ADDENDUM NO. ONE
WARREN WOODS PUBLIC SCHOOLS
HAWTHORN EARLY CHILDHOOD CENTER
RENOVATIONS
Page 1 of 2 (write up only)

March 6, 2015

ADDENDUM NO. ONE to the plans and specifications for the WARREN WOODS PUBLIC SCHOOLS, HAWTHORN EARLY CHILDHOOD CENTER, RENOVATIONS, Architect's Project No. 141596, dated February 23, 2015.

1
A1.0
FIRST FLOOR PLAN
1/4" = 1'-0"

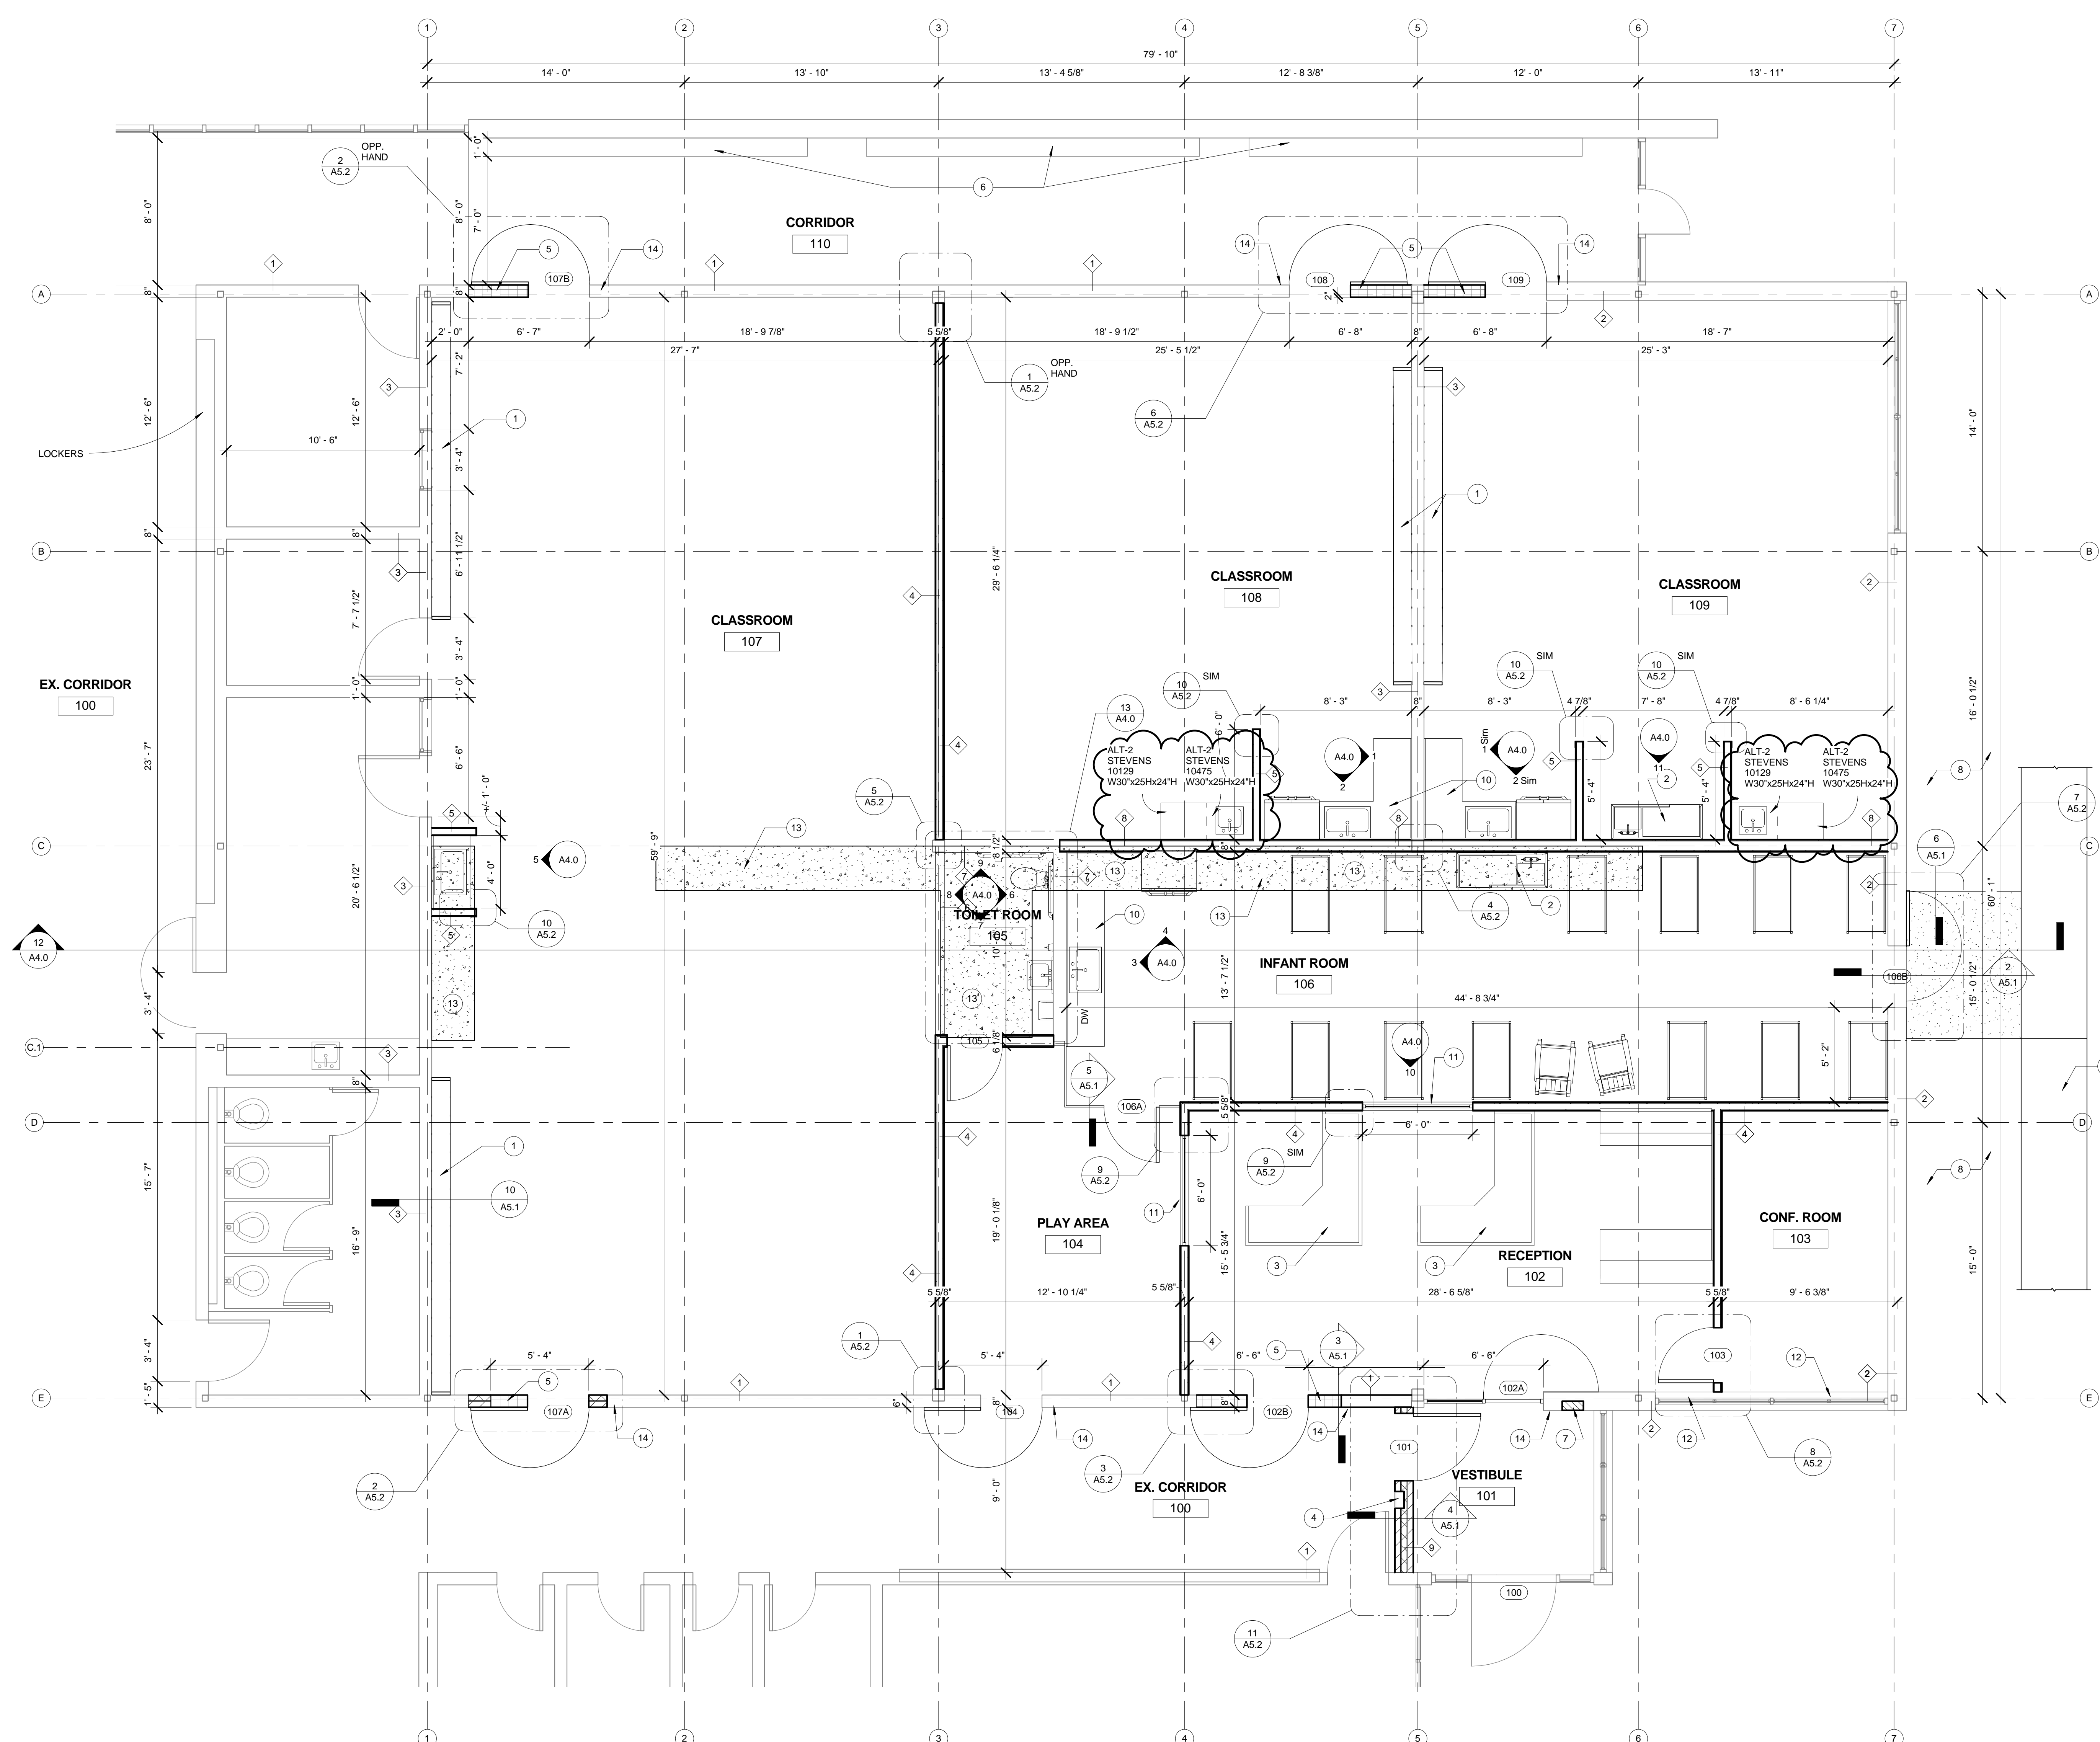
ITEM NO. A3: Refer to drawing A1.0 (reissued):

- a. Added Alternate No. 2 to Bid Form to add (2) sections of casework and sink to Classrooms #108 & #109. Extend sanitary and water lines CW & HW to sinks. Price is to include any floor demo, new concrete hookups and all associated material. Provide sink S-2.

1
E0.1
ELEC. DEMOLITION PLAN
1/4" = 1'-0"

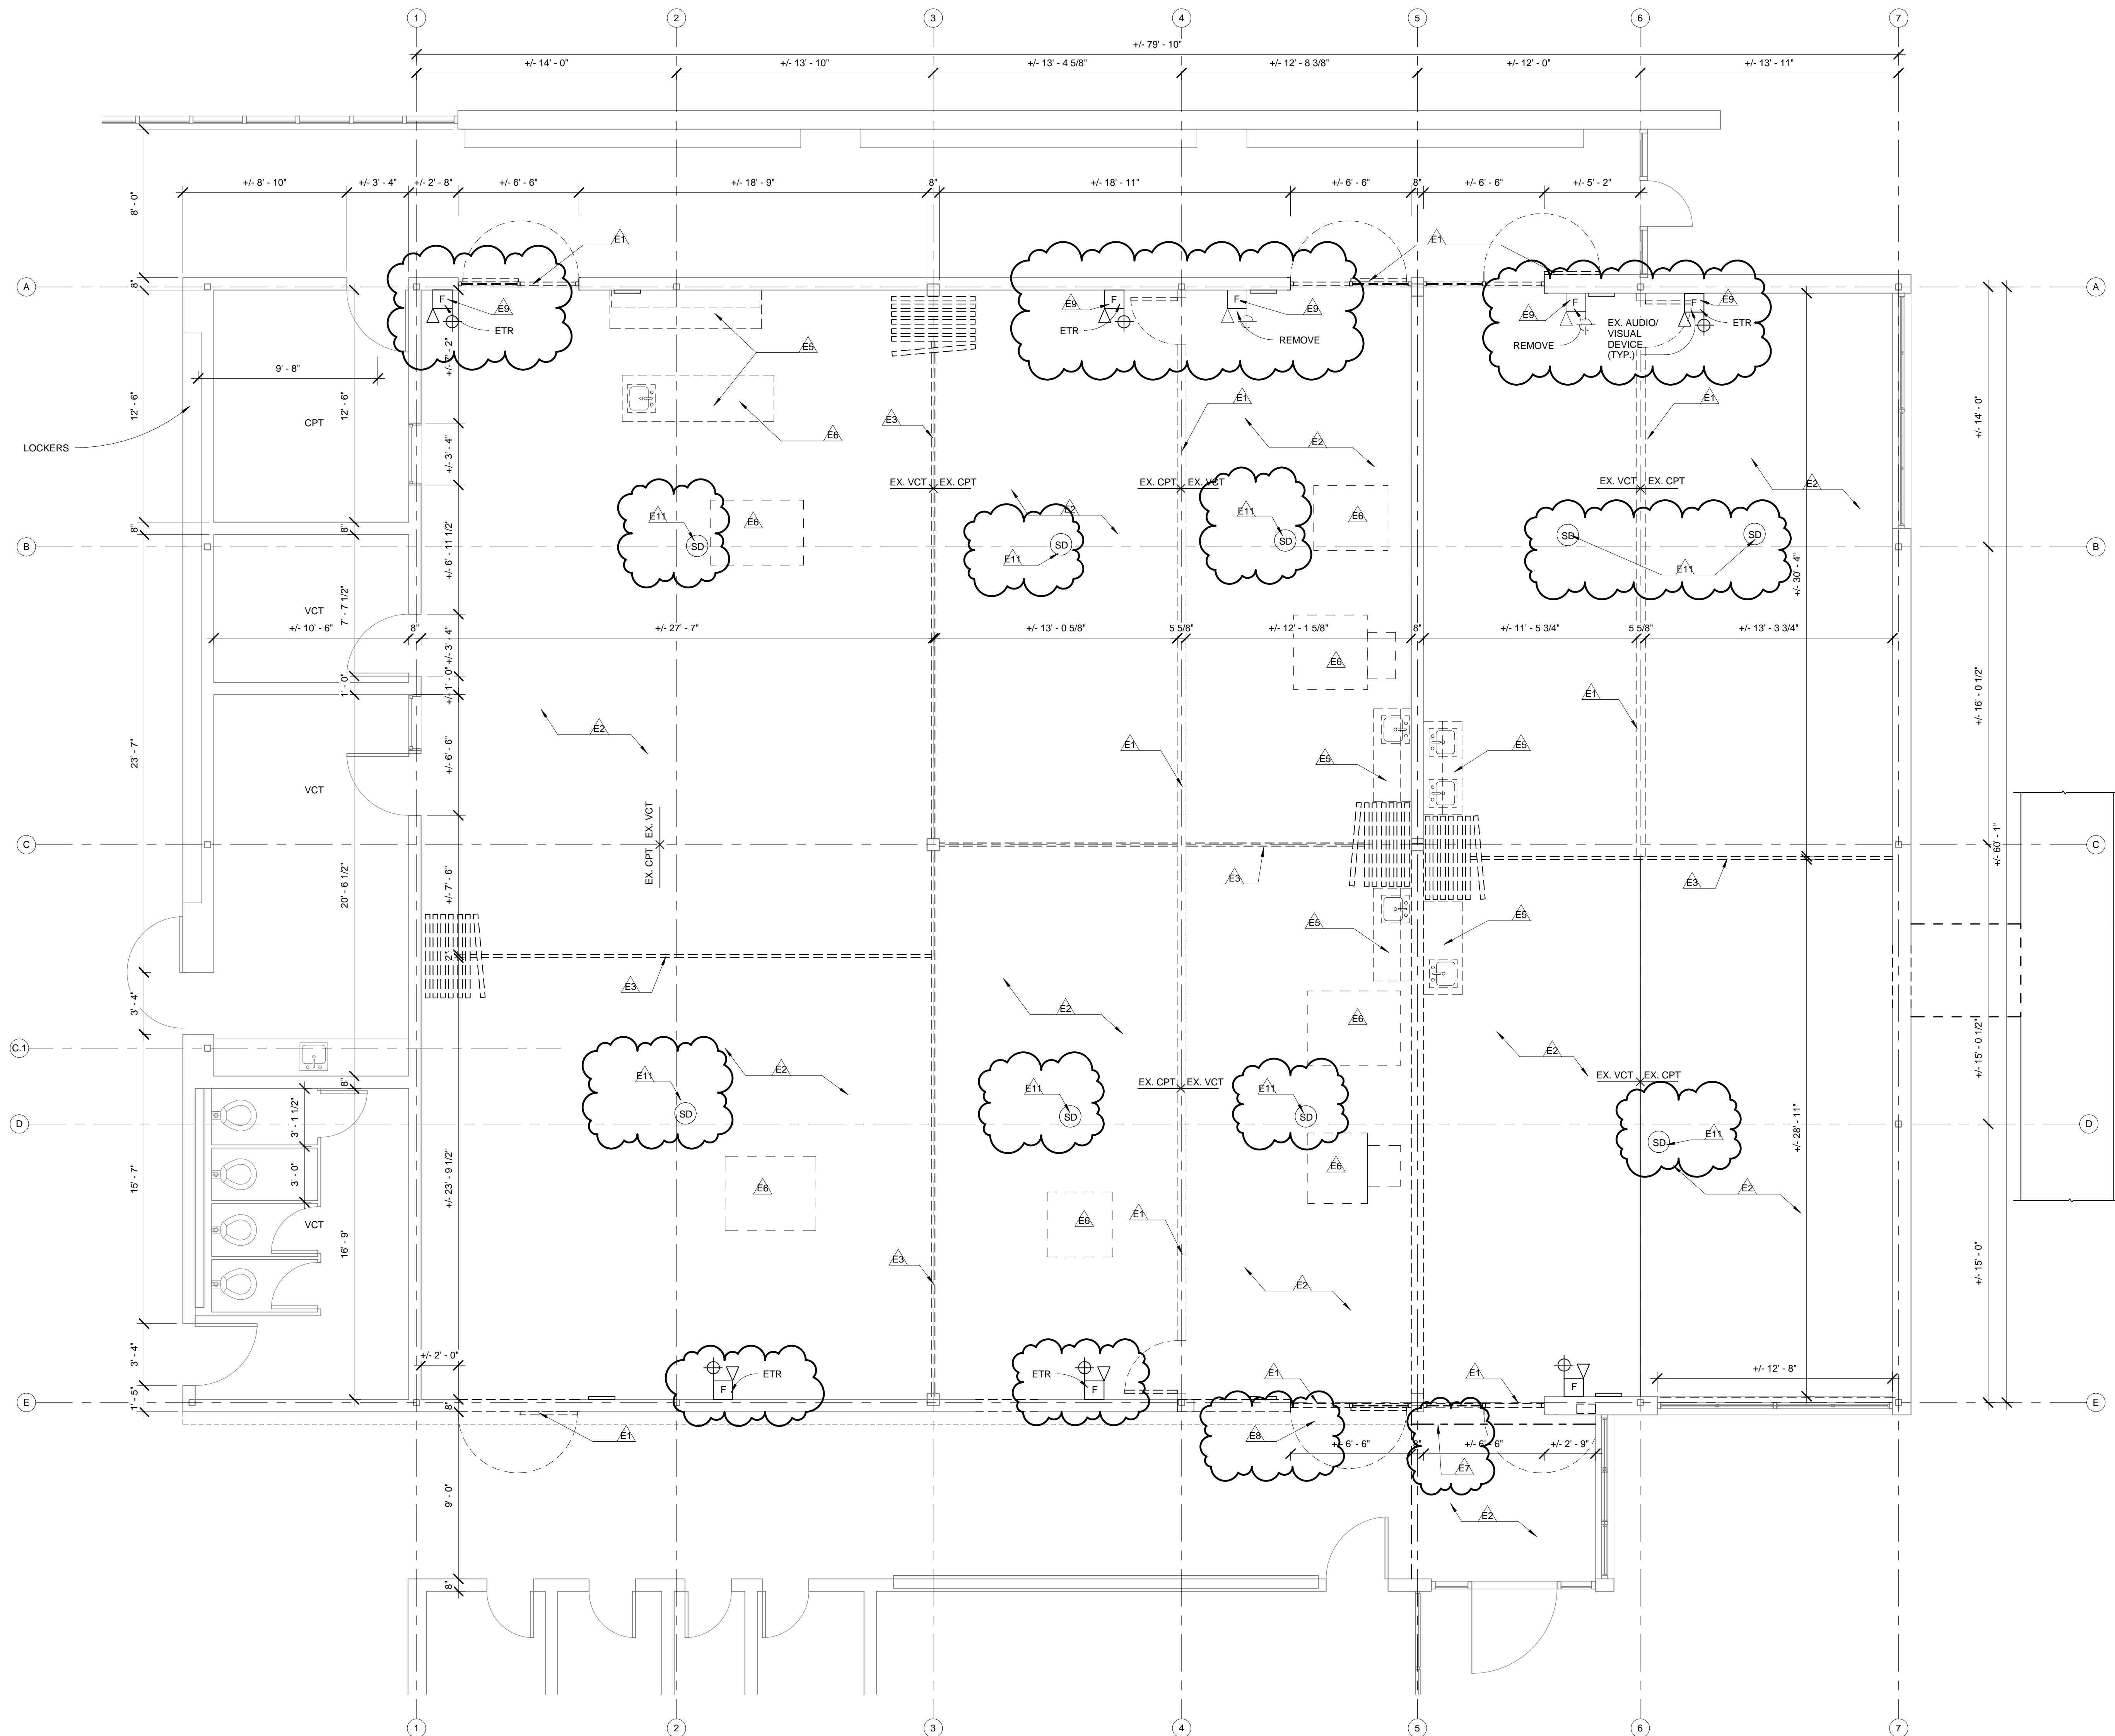
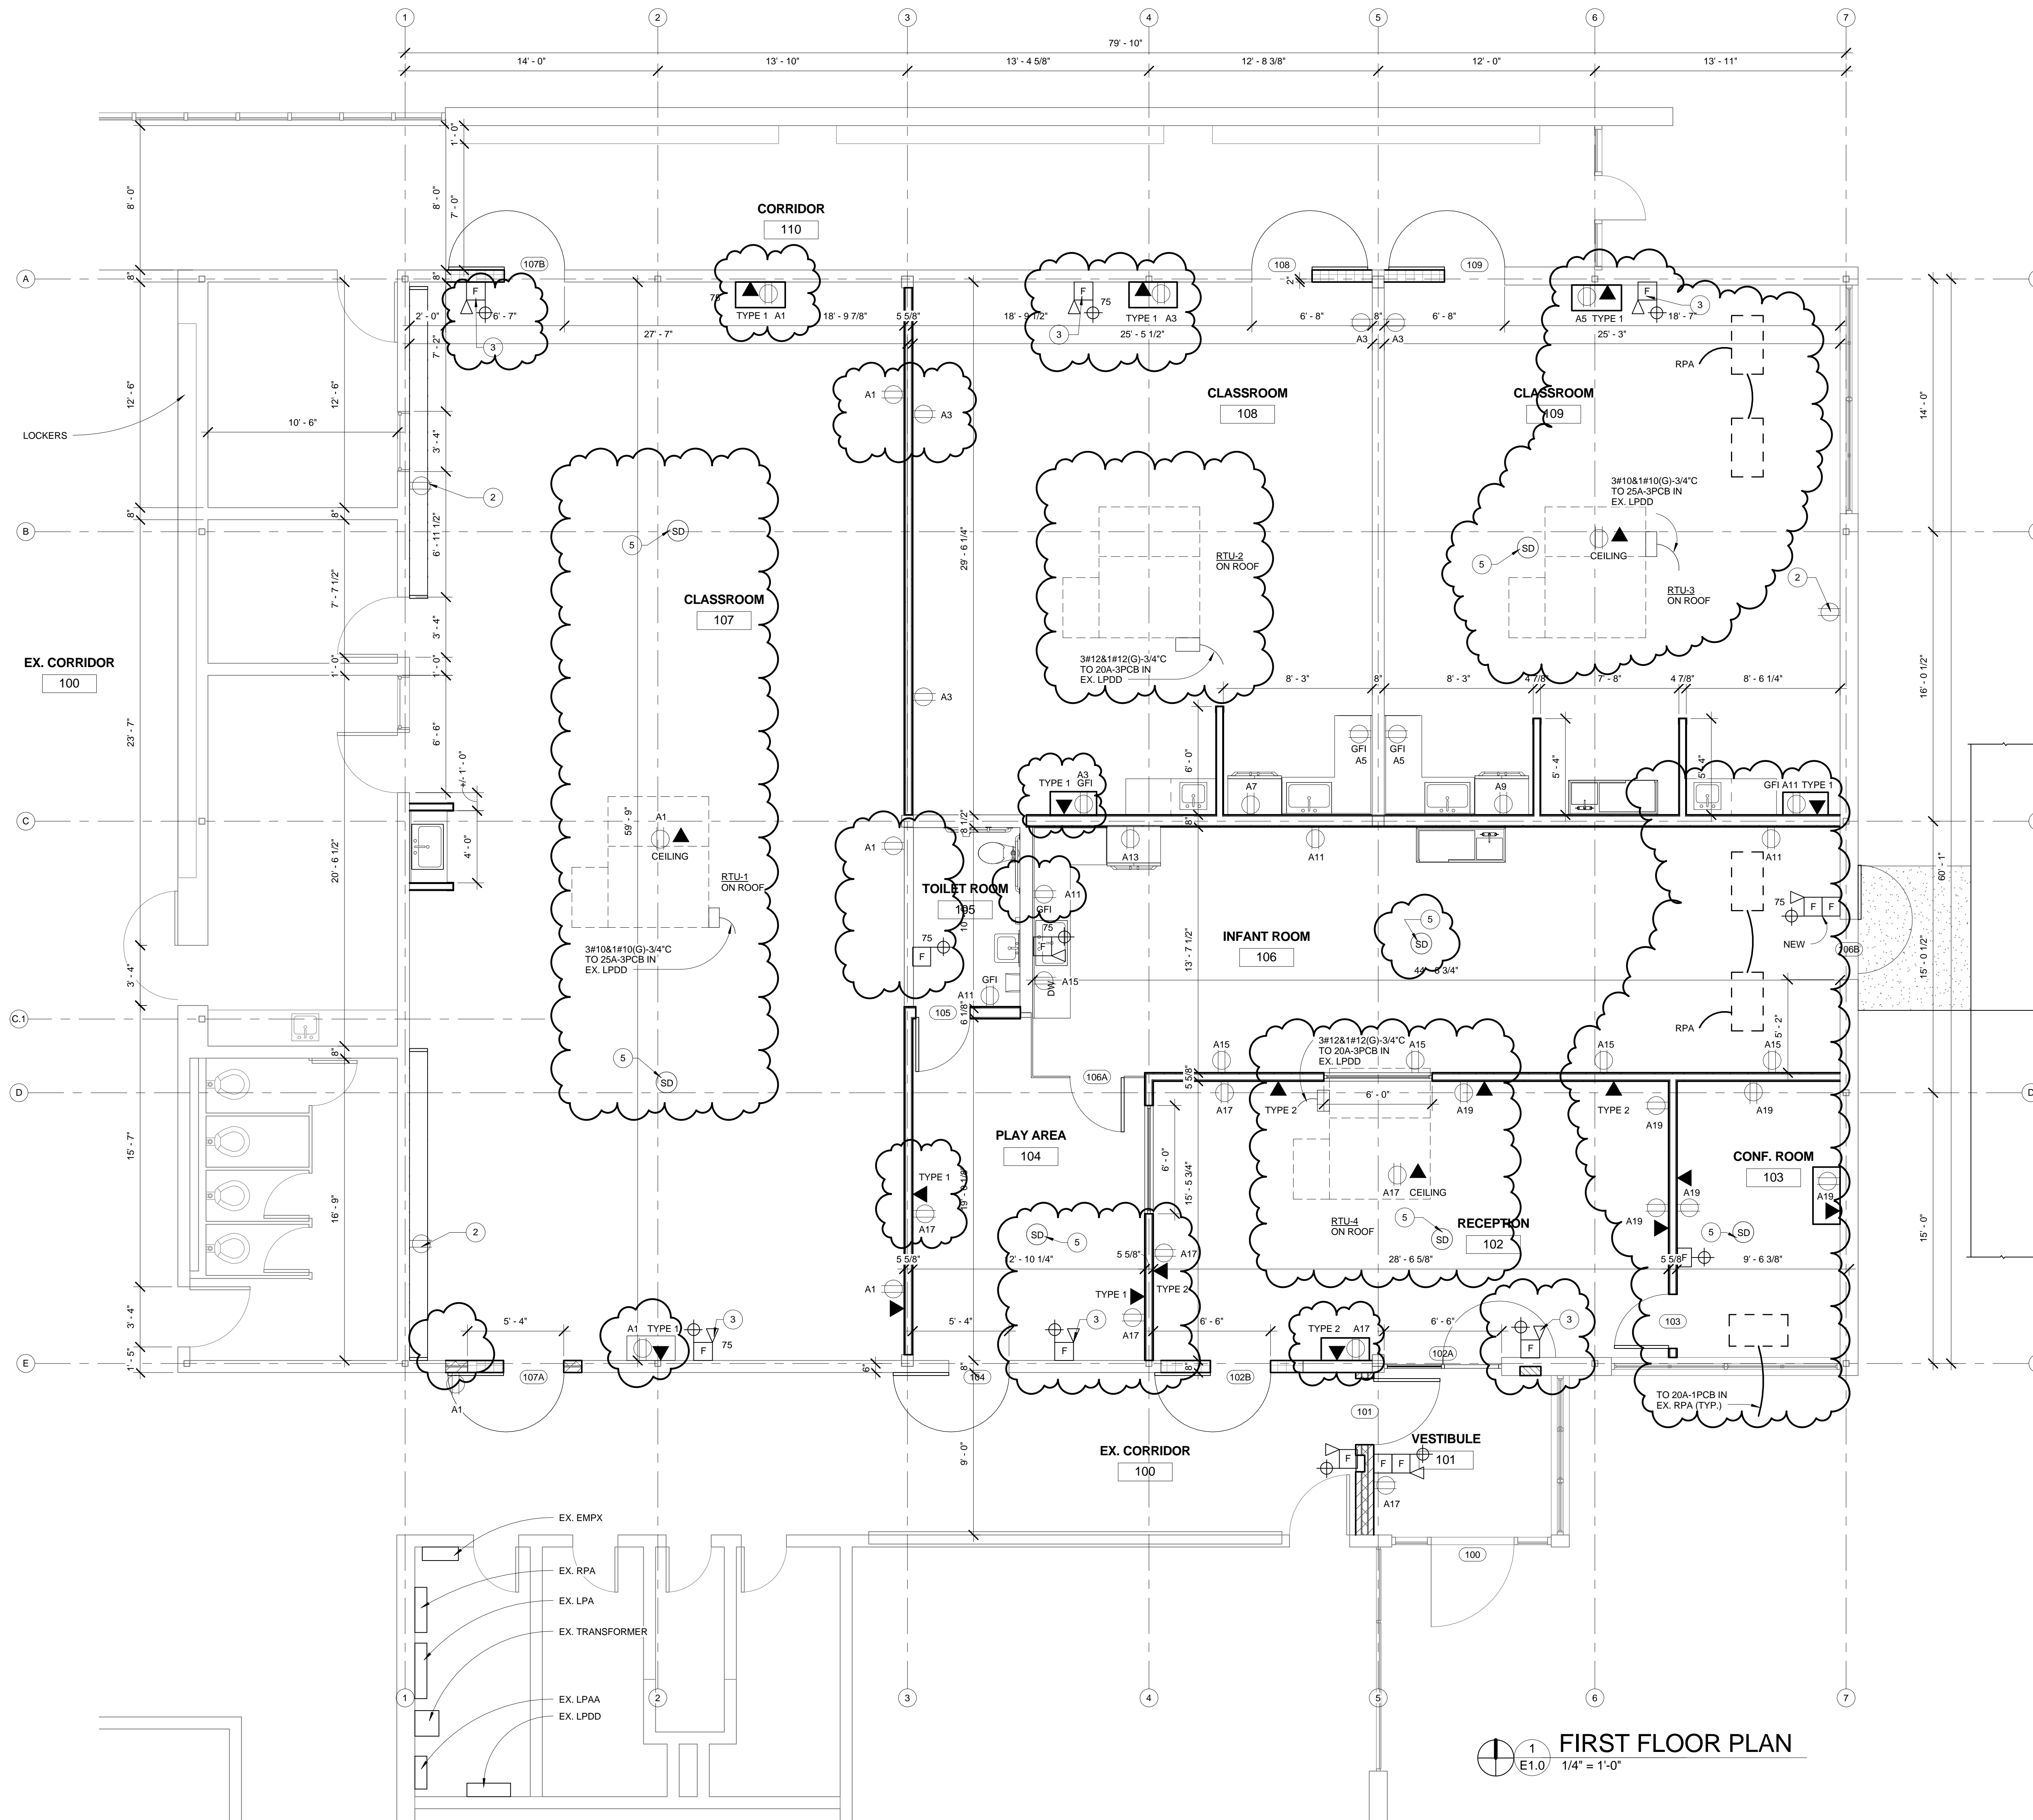
- ITEM NO. E1:** Refer to Sheet E0.1
- a. Delete existing fire alarm audio visual devices where shown. Verify that existing to remain are operating prior to removal.
 - b. Demolition plan notes E7 thru E10 are added and referenced on plan.
- ITEM NO. E2:** Refer to Sheet E1.0
- a. Plan notes 3, 4, & 5 added and referenced on plan.
 - b. Existing floor rough-in in Classroom 107 is to be removed. See Demolition Plan.
 - c. Plant Note 2 deleted.
 - d. Additional technology outlets shown
 - e. Additional receptacle shown.
 - f. Fire alarm devices revised.
 - g. Ceiling and duct smoke detectors shown.
